**INITIAL REVIEW OF THE REMEDIAL  
INVESTIGATION/FEASIBILITY STUDY (RI/FS)  
WORK PLAN**

**06/24/87**

**USEPA/DOE-ORO**

WORK PLAN, DECEMBER 1986

FIGURE 7 Uranium Levels in Soils Adjacent to the FMPC

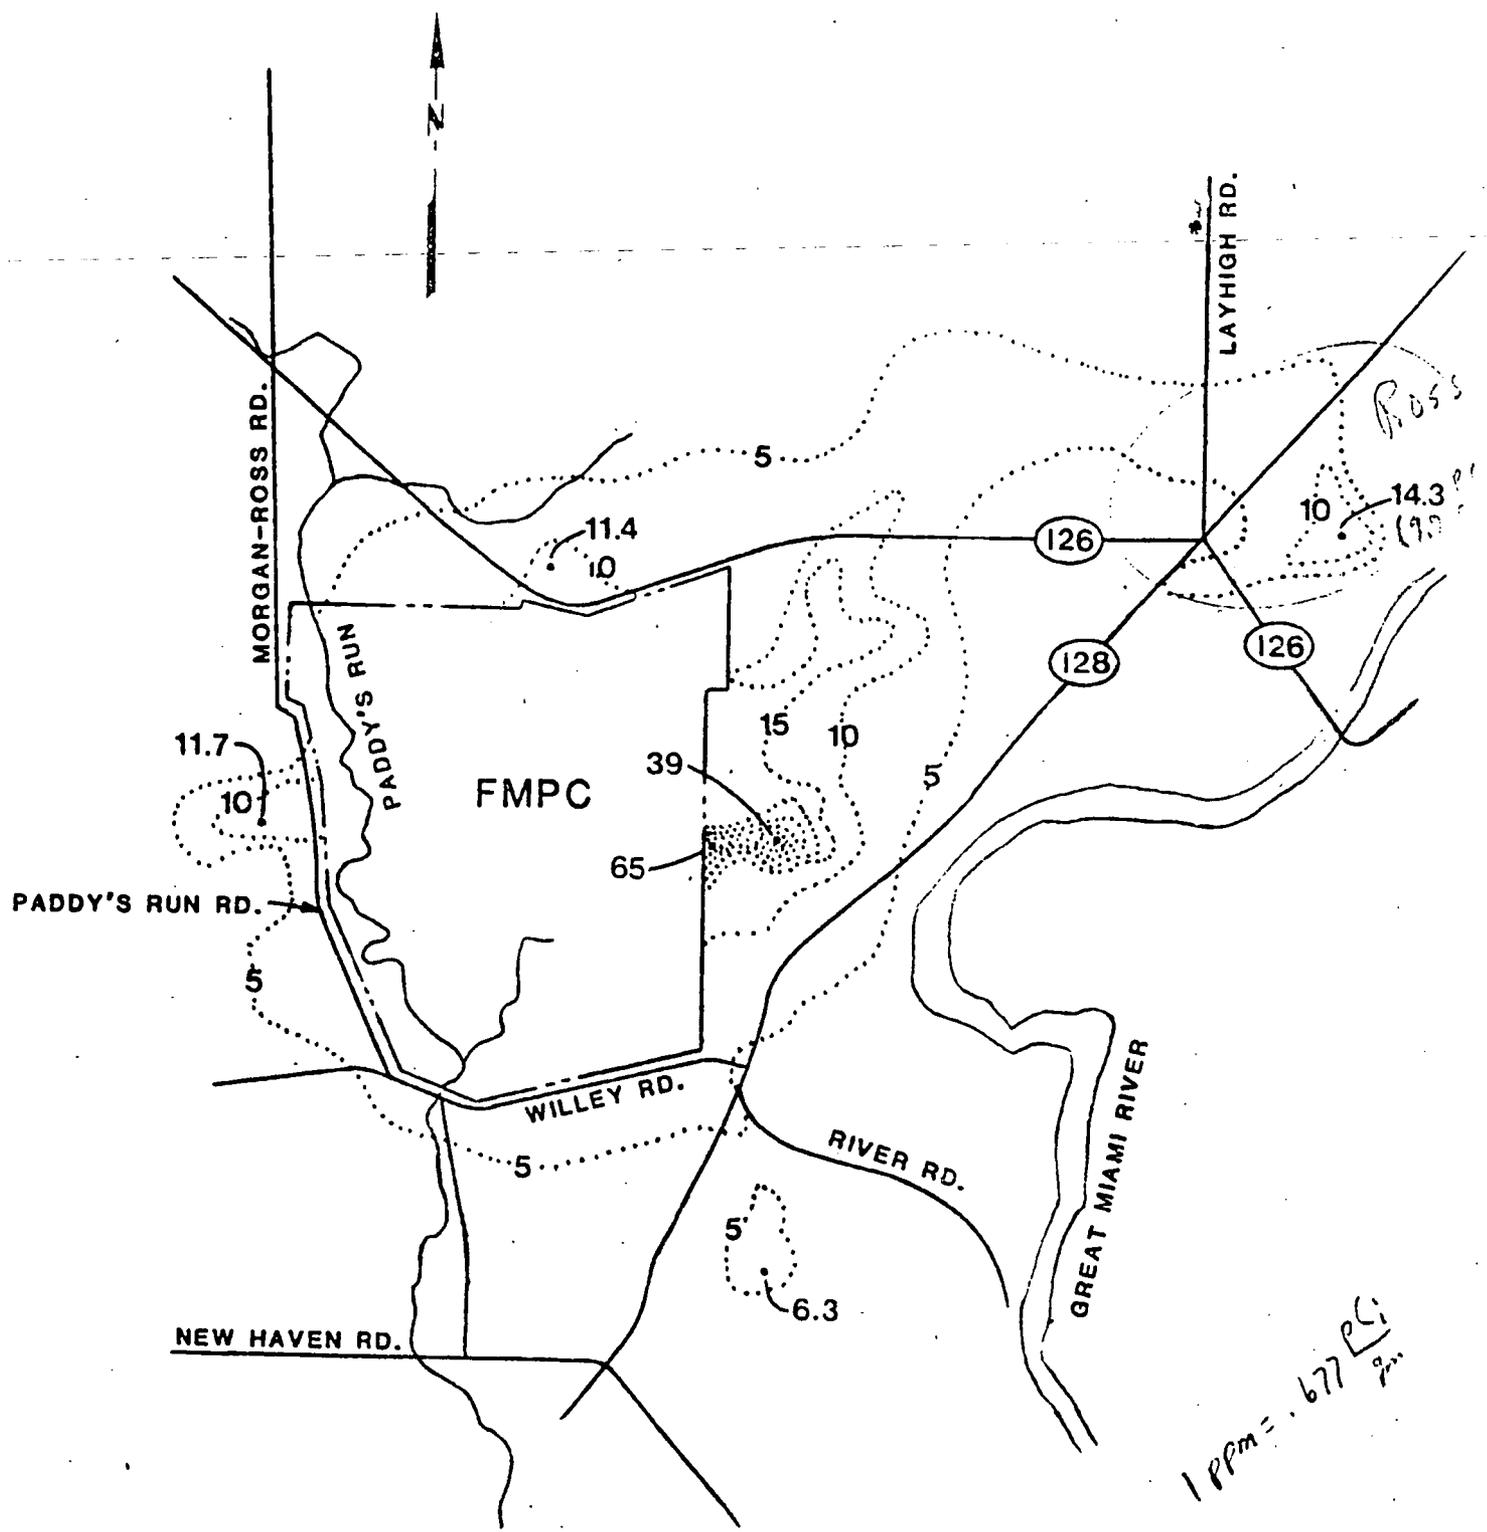
- ° Figure 2.1, page 2-3 displays code numbers that are very difficult to read. Further, the map does not show all site features, i.e. the K-65 silos.
- ° Section 2.1.3, pages 2-4 and 2-5 should include a passage addressing radionuclides in soils. The 1984 Environmental Report, page 20 shows depositions of 65 parts per million (ppm) of uranium at the east fence and up to 14.3 ppm uranium in the nearby town of Ross.

**FIGURE 4.6**  
**SURFACE WATER AND SEDIMENT SAMPLING LOCATIONS**  
*ATTACHMENT 3*

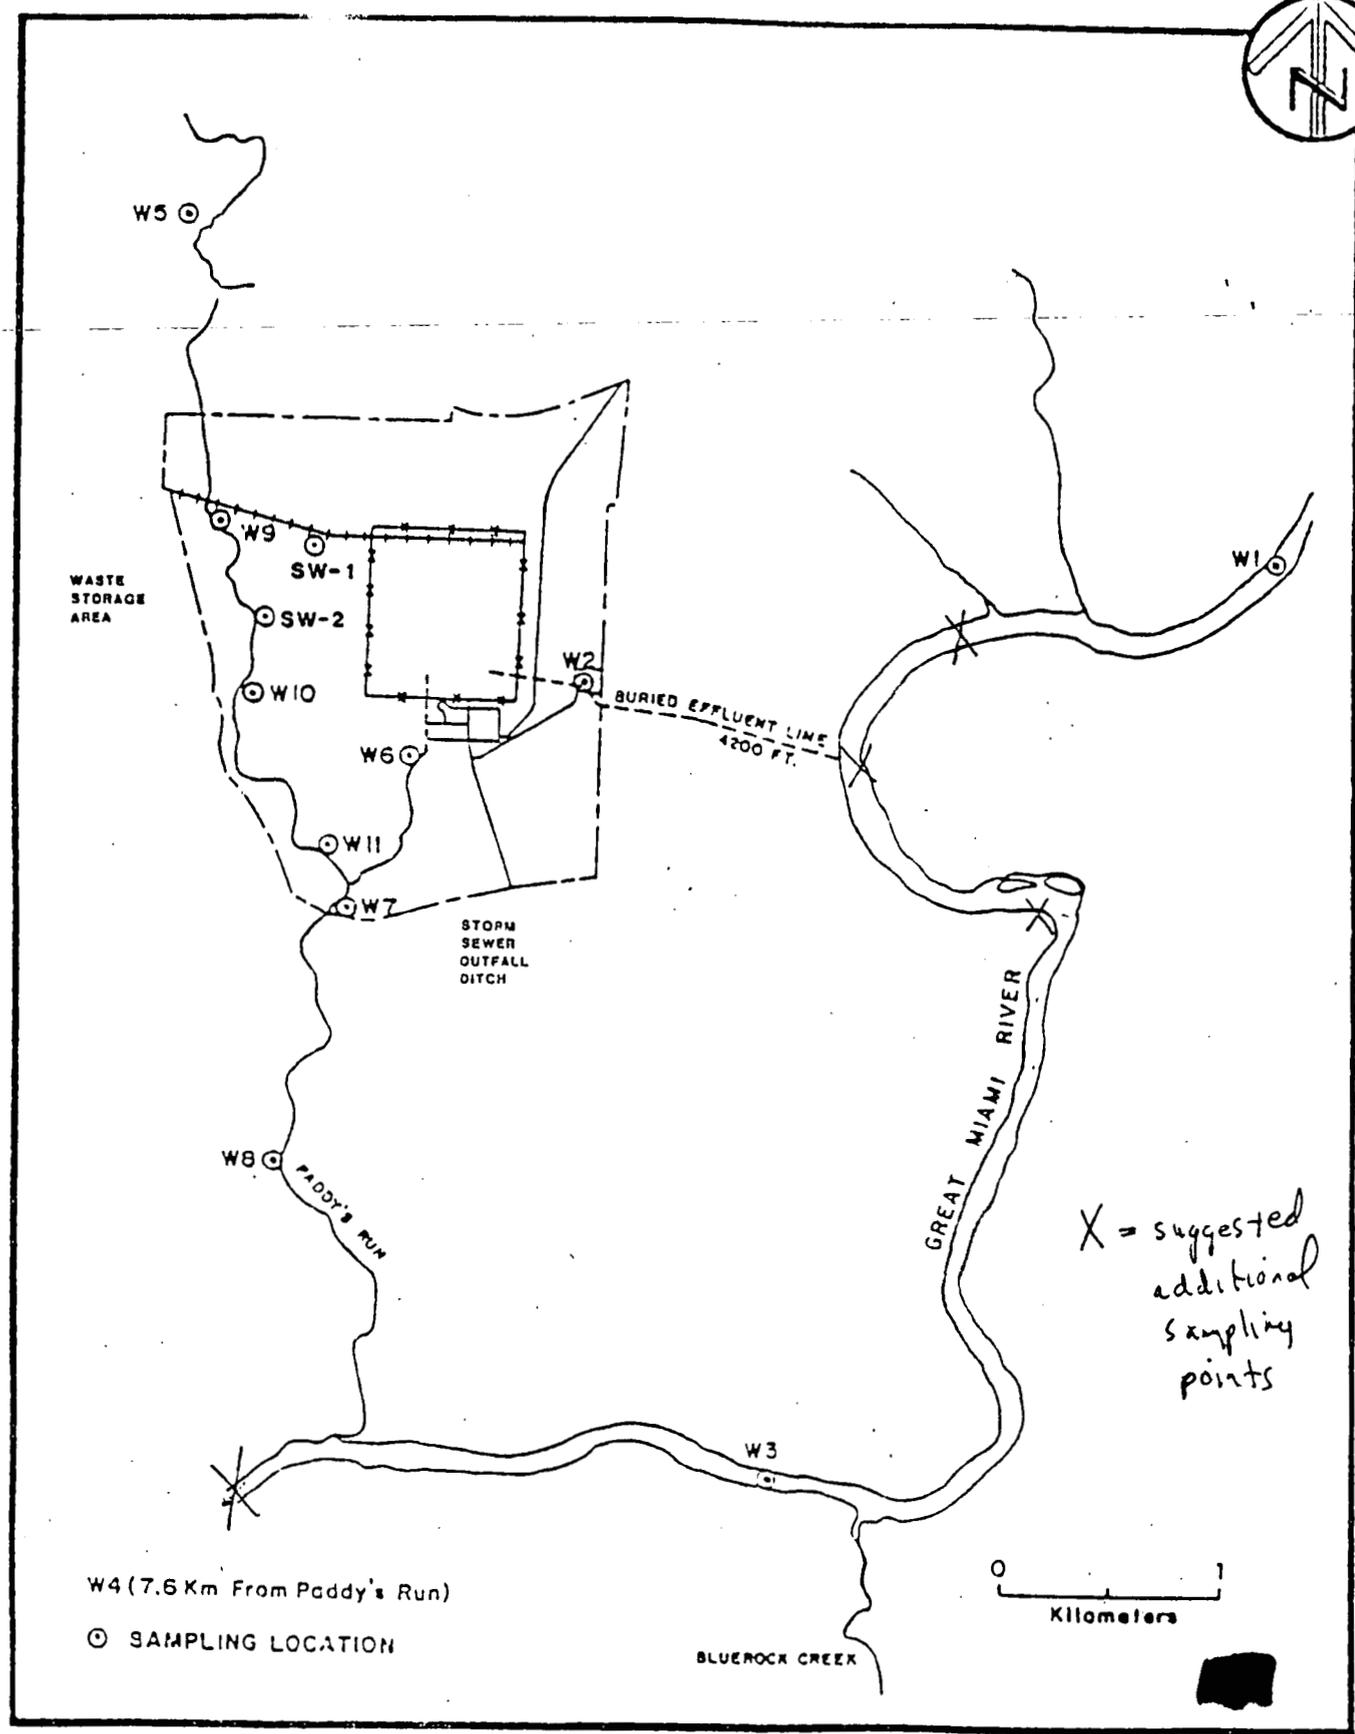
- Figure 4.6, page 4-20 displays an insufficient amount of sampling points along the Great Miami River. This sampling plan will not offer enough information about site problems. We suggest adding the sites shown on Attachment 3.
